## **MINUTES OF THE 11<sup>TH</sup> MEETING OF THE RE-CONSTITUTED EXPERT APPRAISAL COMMITTEE (EAC) ON ENVIRONMENTAL IMPACT ASSESSMENT (EIA) OF THERMAL POWER PROJECTS**

The 11<sup>th</sup> Meeting of the re-constituted EAC (Thermal Power) was held on 26<sup>th</sup> October, 2017 in the Ministry of Environment, Forest & Climate Change at Teesta Meeting Hall, Vayu Wing, First Floor, Indira Paryavaran Bhawan, Jor Bagh Road, New Delhi under the Chairmanship of Dr. Navin Chandra. The following members were present:

**Plate-1 (13.10.2017)**

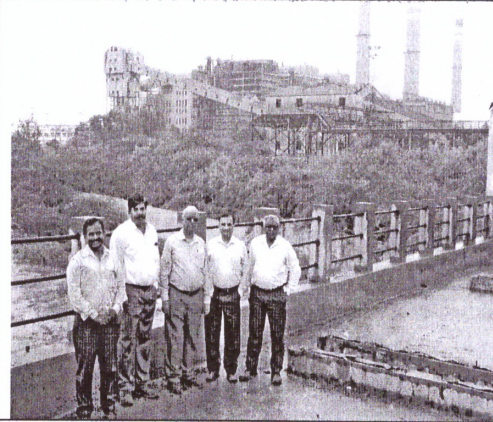
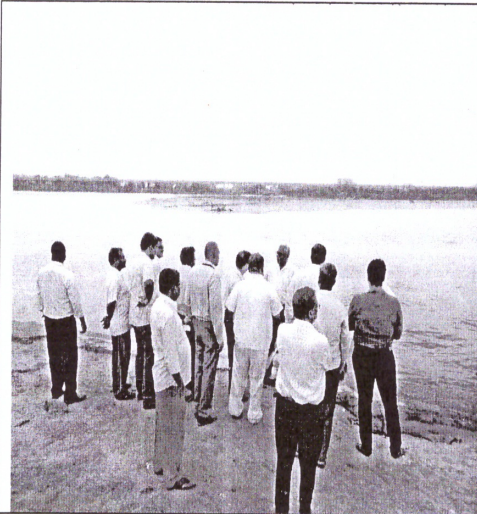
Existing Flyash pond-damaged ash dyke

Sit view of Existing ETPS plant
